# Addendum No. 7 to Contract Documents

Project	Biosolids Process Improvements	CWSRF Project No.	C7-6240-13-00
Owner	The City of Auburn		
Contract No.	BPI-1A General BPI-1B Heating and Ventilation BPI-1C Electrical BPI-1D Plumbing	Date	January 13, 2023

**January 13, 2023**

A-00-010

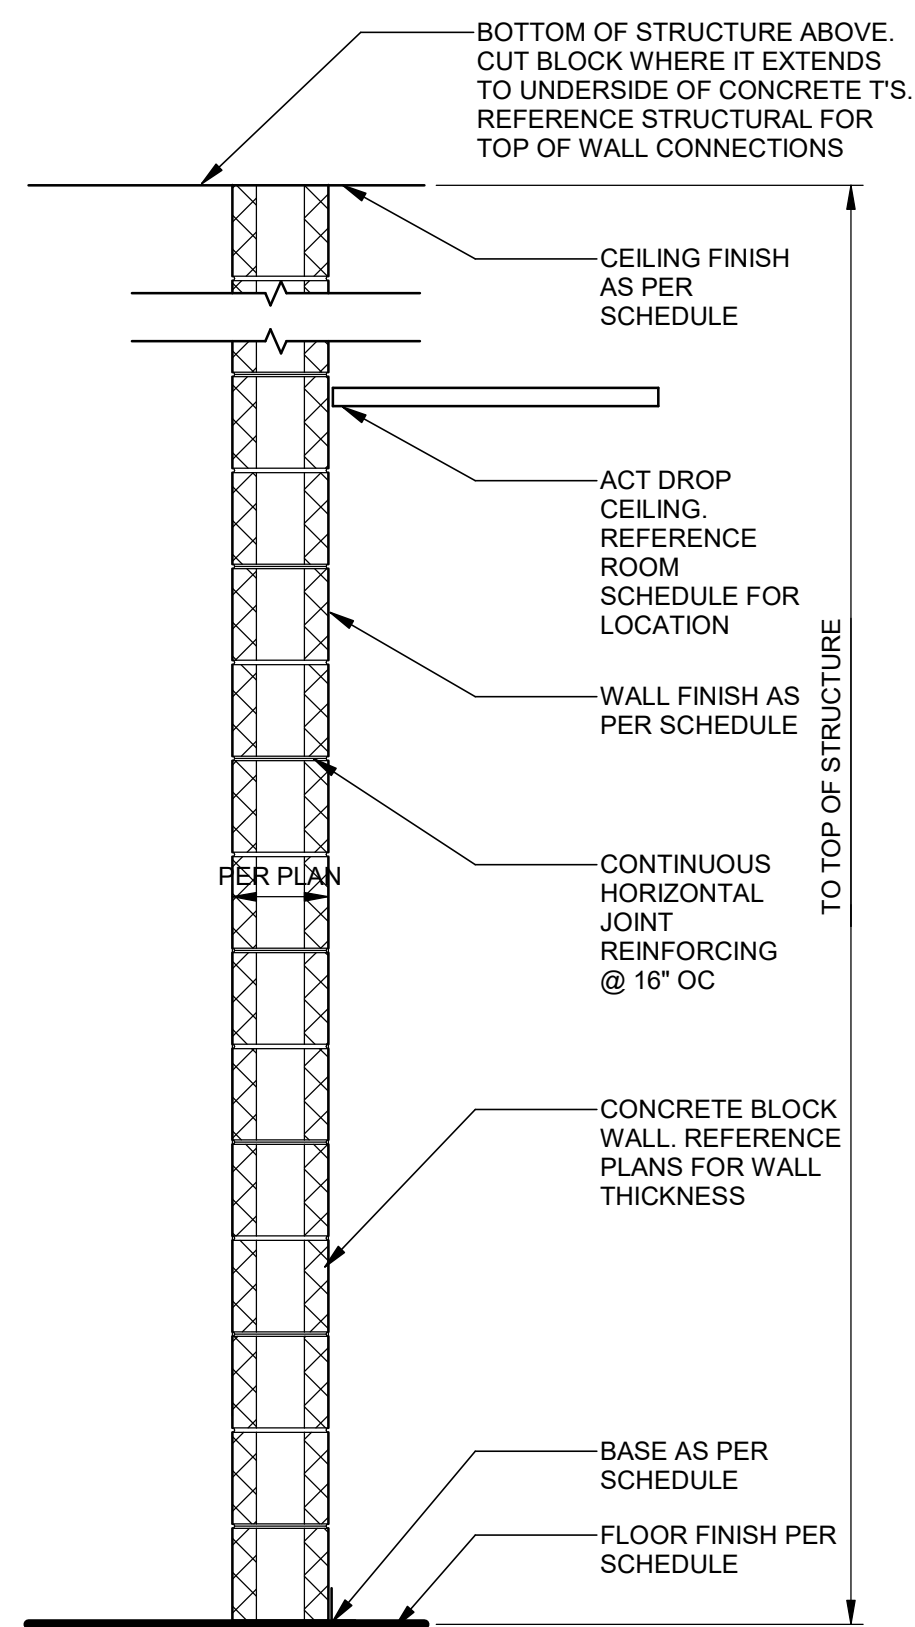
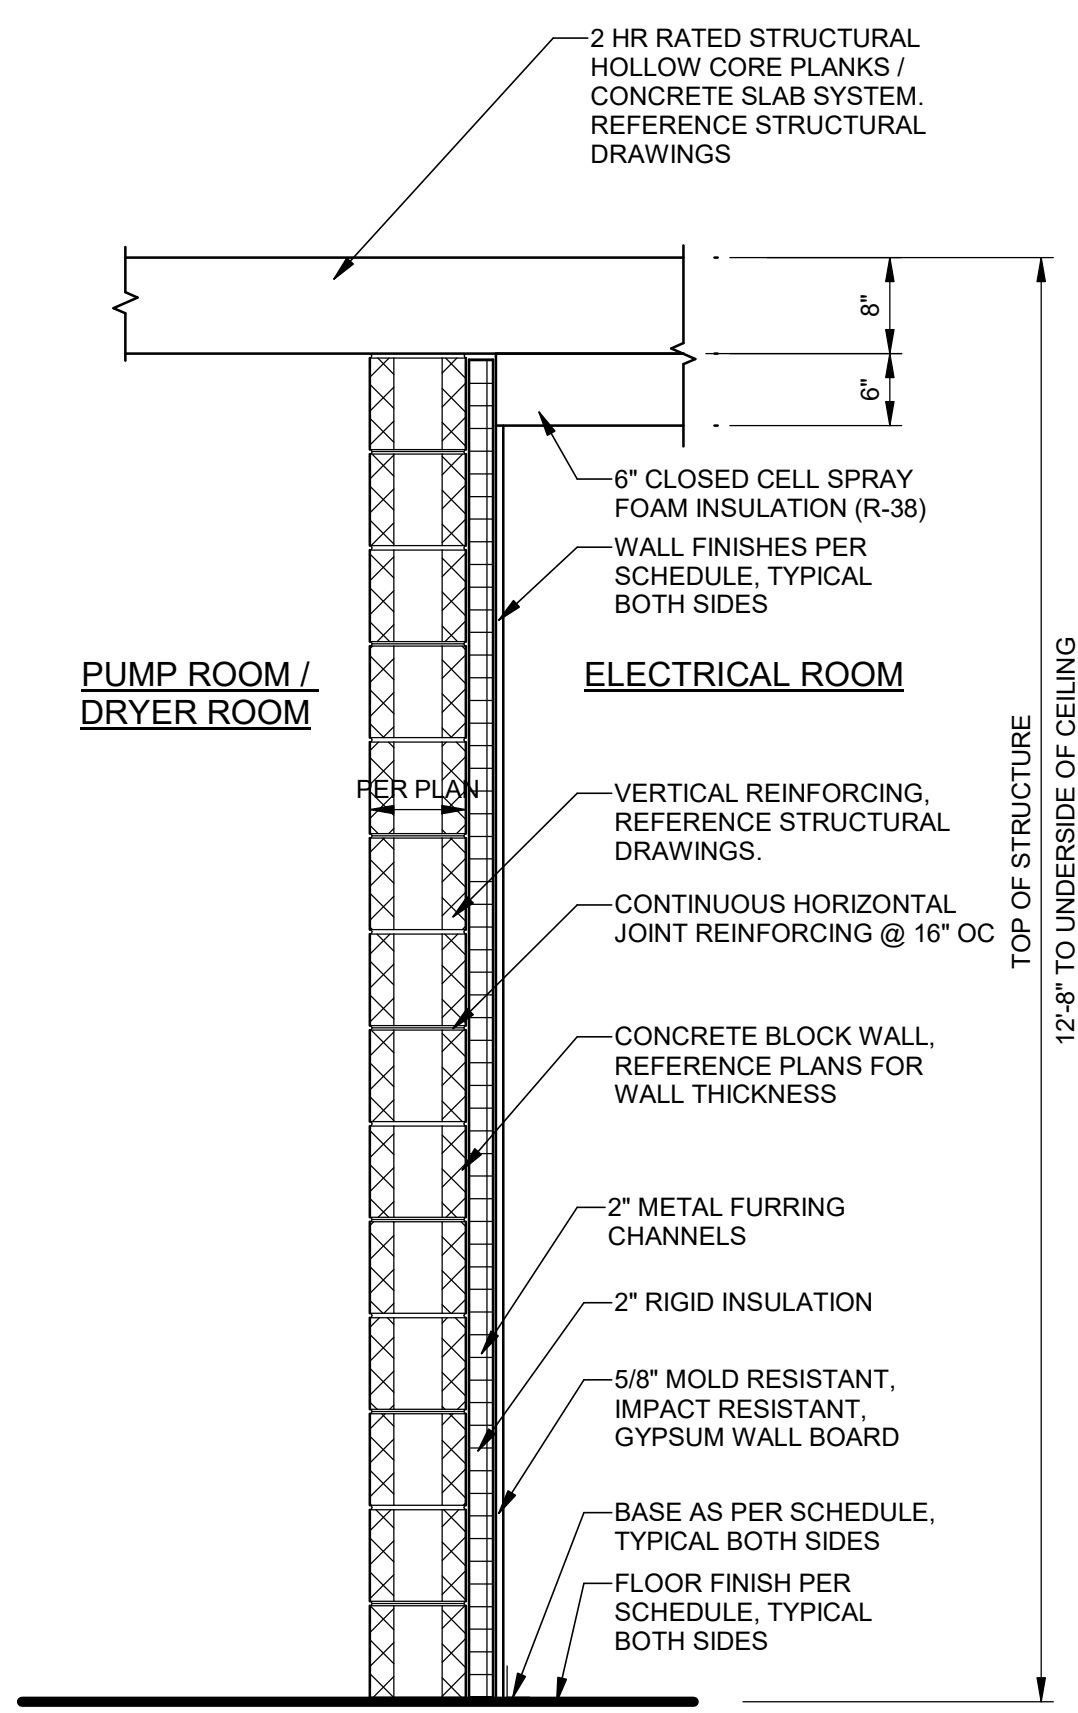
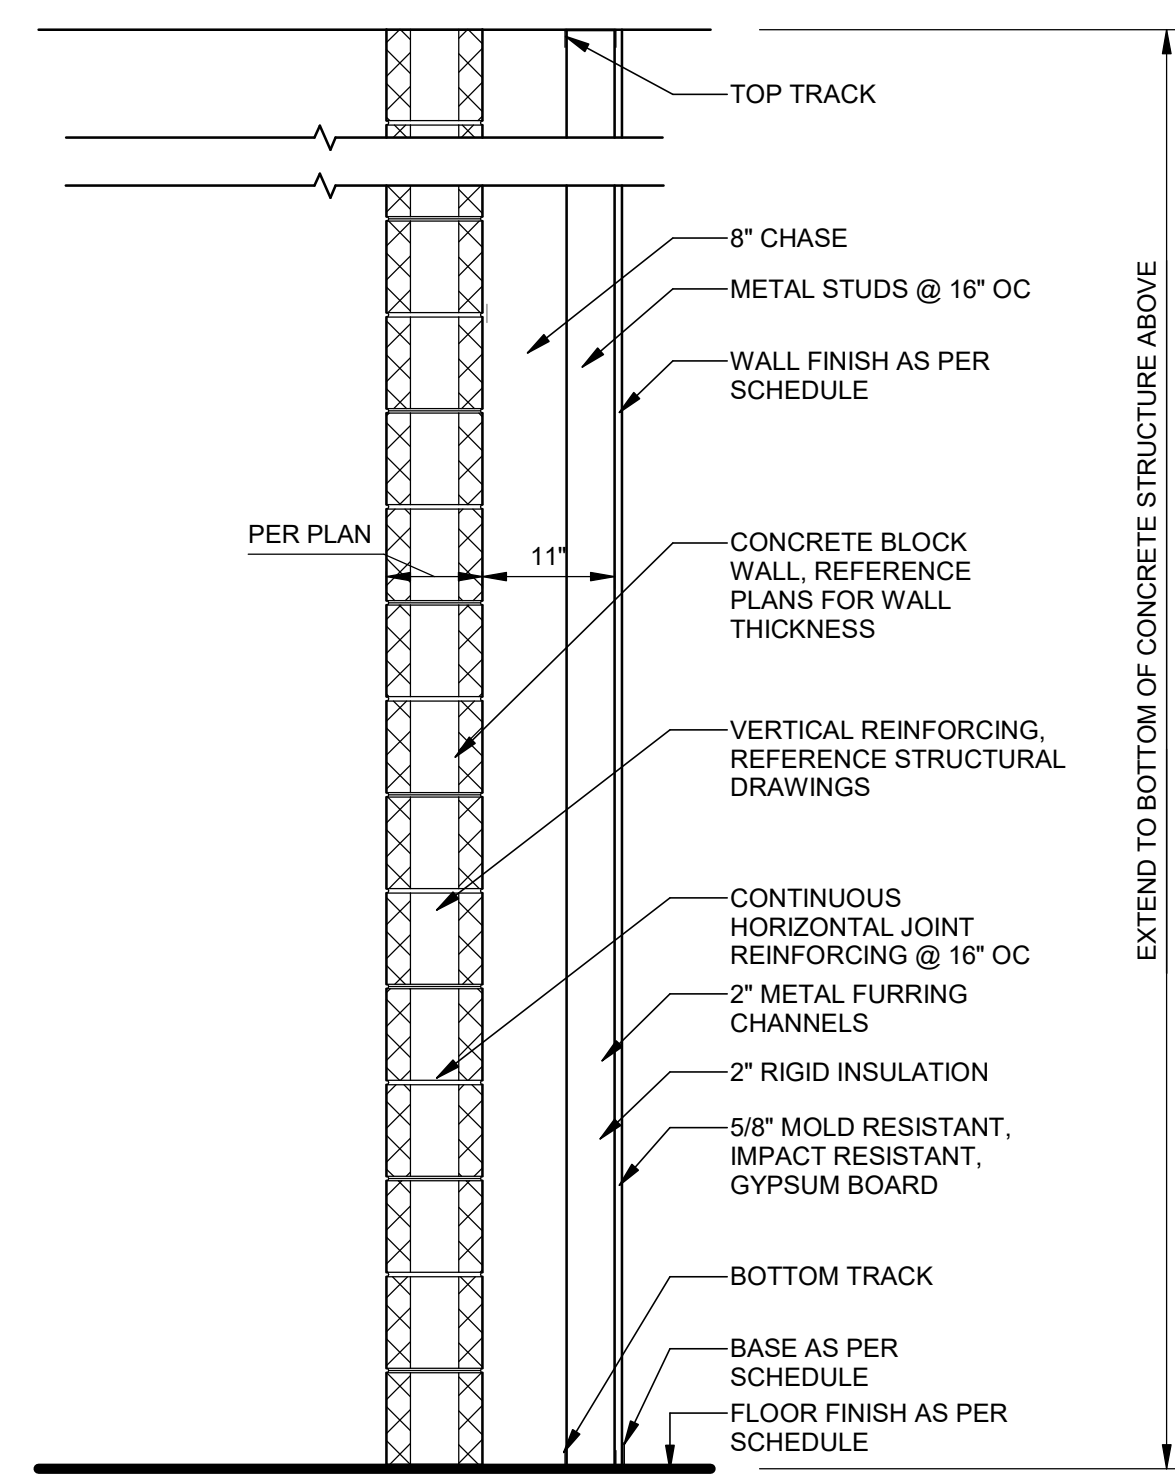
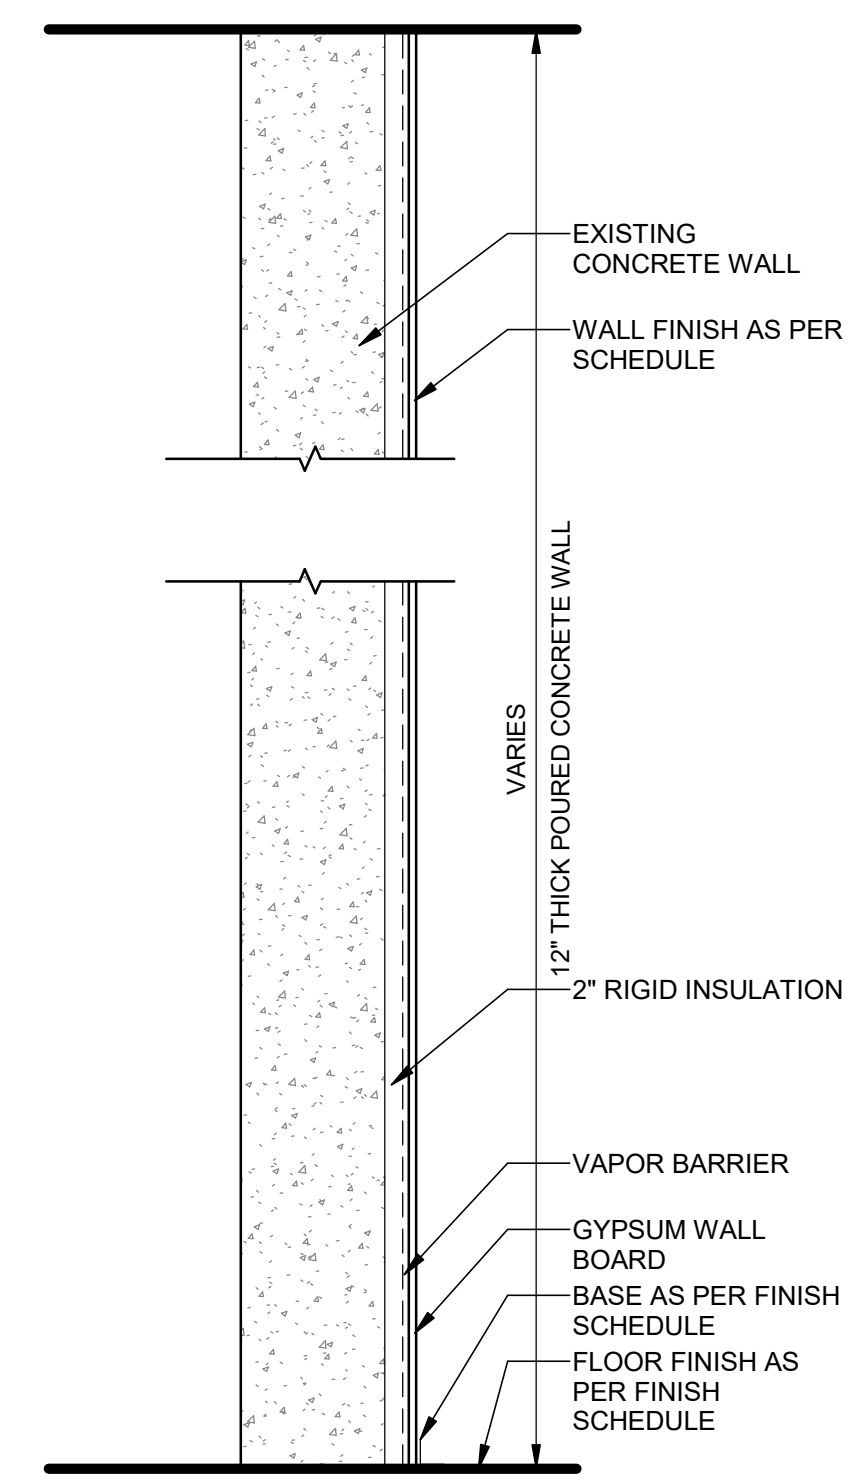
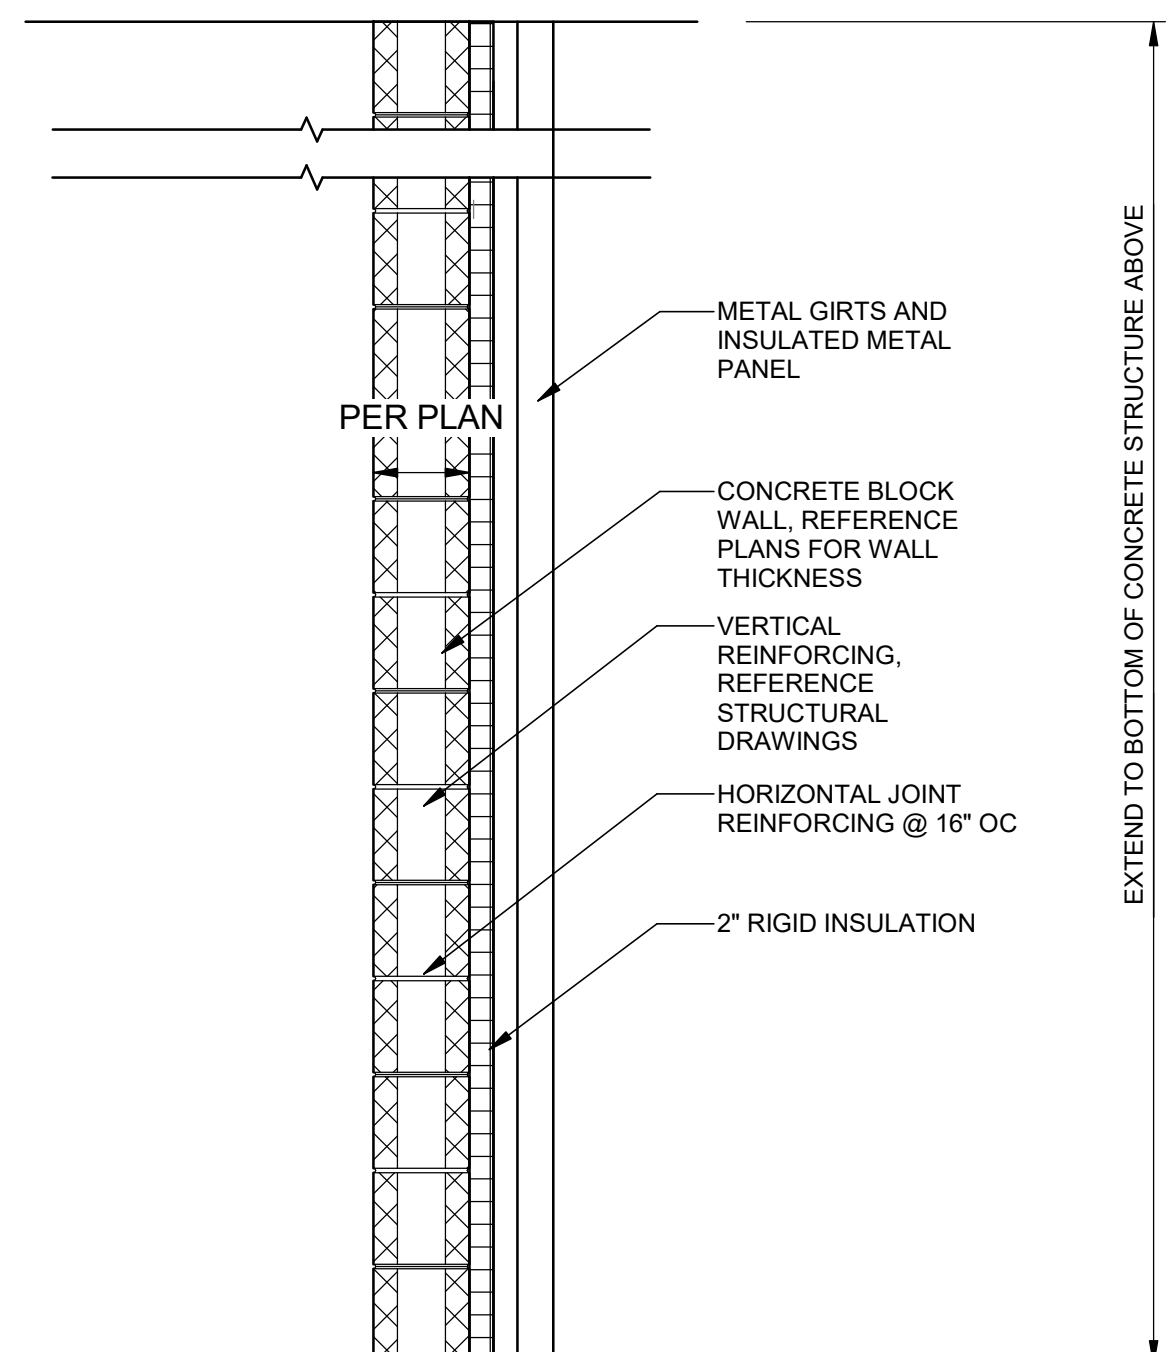
No.	Question Received	Received From	Question	Response	Addendum Required?	Addendum No.	Item No.
275	12/15/2022	Performance Construction Company (Karl Rice)	Where does the 2" 2W line enter the dewatering and dryer bldg.? 2" 2W is shown on C-05-126 running from the cooling tower into the dewatering and dryer bldg. but the 2W line is not shown on the D drawings for the dewatering and dryer bldg.. 2" 2W is also not shown on the partial plan for the cooling tower on dwg D-30-102.	See plumbing drawings			
276	12/15/2022	Performance Construction Company (Karl Rice)	Are the 36" PE, 30" RAS & 4" 3W shown on drawing C-05-126 shown for reference only or are they new lines to be installed?	Those are existing as indicated in grey			
277	12/15/2022	Performance Construction Company (Karl Rice)	Drawing A-30-301 Keynote 20 calls for an insulated ceiling system for the electrical room 102. The finish schedule on drawing A-00-010 calls for a suspended ceiling. Please advise which ceiling is being used.	Keynote 20 is correct. Will provide update on finish schedule on A-00-010 to read as gypsum board	Yes	7	22

345	12/22/2022	KC Masonry Inc (Jason Williams)	Drawing A-20-101 shows a 12" CMU wall at stair 1. Drawing S-20-101 shows 8" CMU wall. Which one is correct?	8" CMU is correct	Yes	7	22
346	12/22/2022	M.A. Bongiovanni (Andrew Bongiovanni)	General Conditions Article 10 Insurance Requirements - Appendix A states the Builder's Risk policy shall contain flood coverage - what limits are required for the flood insurance? It is not normal to cover 100% of the full value of the work, and given the size of the contract there will be considerable cost associated with such a high limit. Normally smaller limits are set for flood coverage. Please advise if the City requires the flood insurance coverage to be the full value of the work or a lesser limit.	Flood Coverage requirement will be reduced to \$1 Million	Yes	7	2
347	12/22/2022	M.A. Bongiovanni (Andrew Bongiovanni)	Question #23 clarified that the Electrical Contract was providing all VFDs listed in 26 29 23, and all other equipment utilizing integral VFDs shall be provided by the GC. Please confirm the GC is only providing integral VFDs for equipment under the GC scope of supply, not for equipment provided by other Prime Contracts.	Confirmed
